Access Compliance Report

Public Rights-of-Way

(Curb Ramps)

Intersection ID: N/A	Main Street: PAISLEY_ABBEY_LN	Cross Street: KELBURN_LN	Location: SE
ADA ID: E8E4999F7ECE	Ramp Type: BlendTrans1	Initial Pass/Fail: Fail	Overall Compliance: No
Severity Score: 8.75			
Codes/Mitigation Info/Possible Solution		Field Measurements/Component Compliance

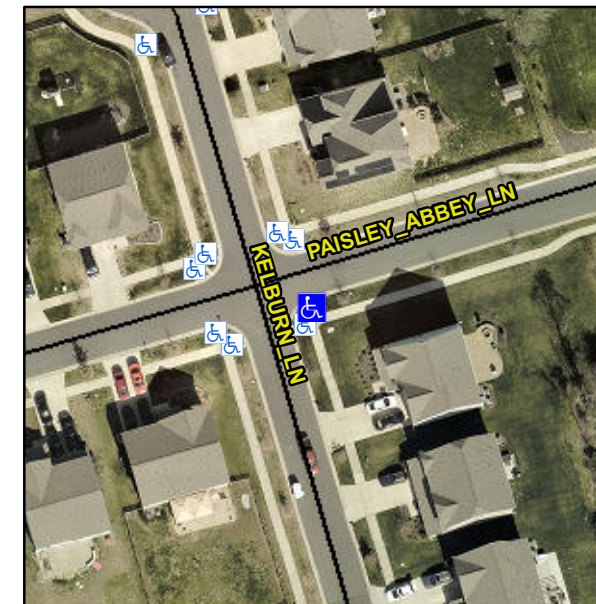
Not Found, R304.5.1

Compliance	Description	Data	Compliance	Description	Data
N/A	Ramp Length (in)	97.0	Yes	BlendTrans Slope (%)	2.5
No	Ramp Width (in)	46.0	Yes	BlendTrans XSlope (%)	1.0
N/A	Flare Type LT	N/A	N/A	Flare Type RT	N/A
N/A	Flare Slope LT (%)	N/A	N/A	Flare Slope RT (%)	N/A
N/A	Flare Traversable LT?	N/A	N/A	Flare Traversable RT?	N/A
N/A	Landing Length (in)	N/A	N/A	DWS Provided?	N/A
N/A	Landing Width (in)	N/A	N/A	DWS Contrast?	N/A
N/A	Landing Slope (%)	N/A	N/A	DWS Length (in)	N/A
N/A	Landing X Slope (%)	N/A	N/A	DWS Full Width?	N/A
N/A	Landing Curb? (Y/N)	N/A	N/A	DWS Offset (in)	N/A
N/A	Shared Landing?	N/A			
N/A	Gutter Ponding?	N/A	N/A	Gutter Slope (%)	N/A
N/A	Gutter Lip Ht (in)	N/A	N/A	Gutter X Slope (%)	N/A
N/A	Painted X Walk1?	No	N/A	Painted X Walk2?	N/A
	X Walk 1 Direction	To N		X Walk 2 Direction	N/A
	X Walk 1 Width (in)	N/A		X Walk 2 Width (in)	N/A
	X Walk 1 Slope (%)	2.3		X Walk 2 Slope (%)	N/A
	X Walk 1 X Slope (%)	1.1		X Walk 2 X Slope (%)	N/A

N/A	Ramp inside XWalk1?	N/A	N/A	Ramp inside XWalk2?	N/A
	Road Slope (%)	1.1		Clear Space?	N/A
	Road X Slope (%)	2.3	N/A	Clear Space to XWalk (in)	N/A
N/A	Any Obstructions?	N/A	N/A	Storm Grate/Utility Hazard?	N/A
	Obstruction Type			Storm Grate/Utility Type	
		N/A			N/A
			Yes	Surface Condition? (G/P)	Good
			No	Curb Slope (%)	8.4

Remove & Replace Curb Ramp With Two New Directional Ramps or Equivalent.
